Urgent Field Action Notice for Instrument ASP6025

ASP6025 Tissue Processor

Description of the problem:

Alarm Connectors labelling

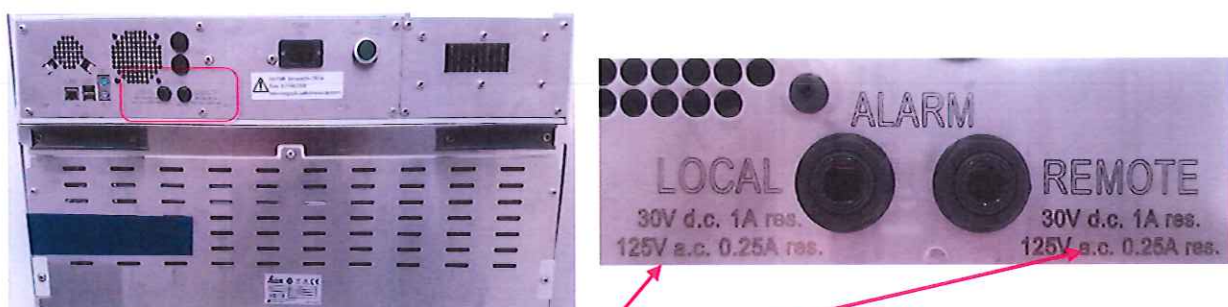
The affected devices mentioned above have incorrect labelling with regard to the specified voltage for the Alarm Connectors on the rear side of the instrument (please refer to the pictures below).

The current incorrect labels specify 125Va.c. as maximum voltage. It has been identified, that if somebody connects such 125Va.c. to the 6.3mm stereo jack, there would be hazardous voltage accessible on the plug which could lead in the worst case to a serious electrical incident.

As outlined on the new label, the maximum voltage that can be applied to the Alarm Connector is 30V DC/AC. In case you do not use the External Alarms no further immediate action is necessary. For ASP 6025 Tissue Processors where the external Alarm is used, please ensure that the maximum voltage is not exceeded by the connected external device.

Fig. 63

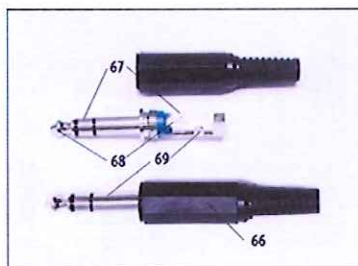
In addition, the current specification in the Instruction for Use (IFU) has an incorrect labelling with regard to the specified voltage for the Alarm Connectors (please refer to the pictures below).

The translated IFU's on the CD (part# 14049580200) and the "online help" of the Instruments have also an incorrect labelling with regard to the specified voltage of the Alarm Connectors.

1. Adhesive label:

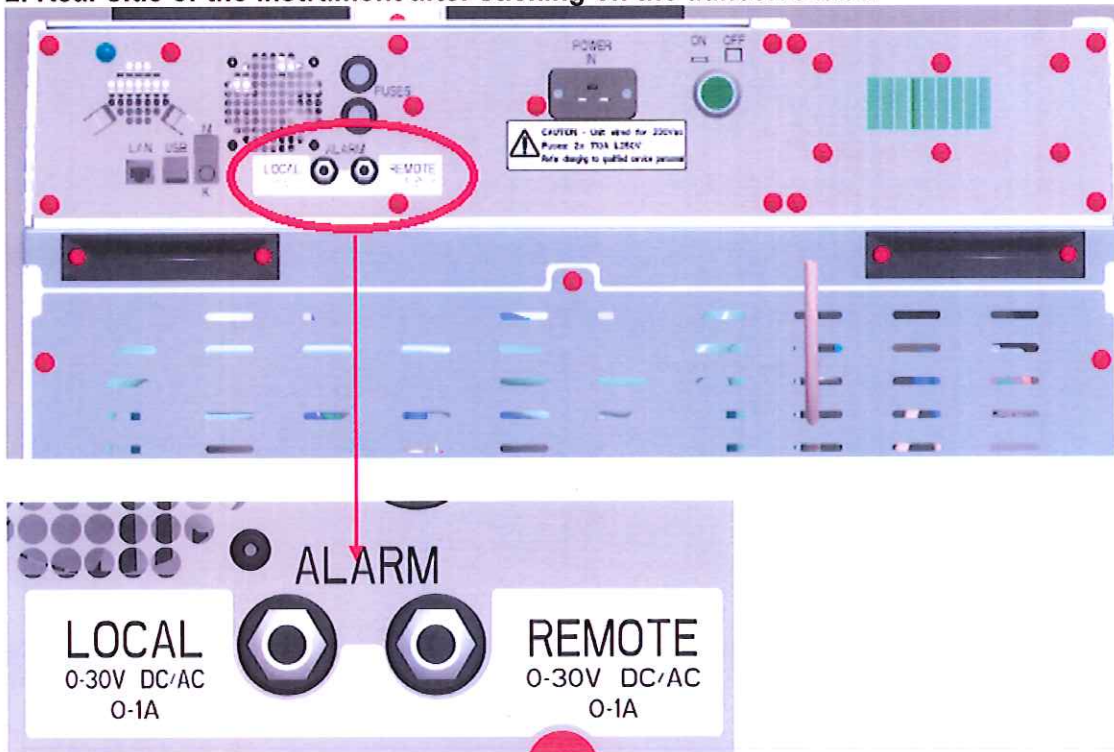
As an immediate action, we ask that you to first clean the surface around the Alarm Connectors (grease free). Then remove the provided adhesive label (1) from the foil and place it at the Alarm Connectors as shown in the pictures below. The engraved specification must not be readable anymore!
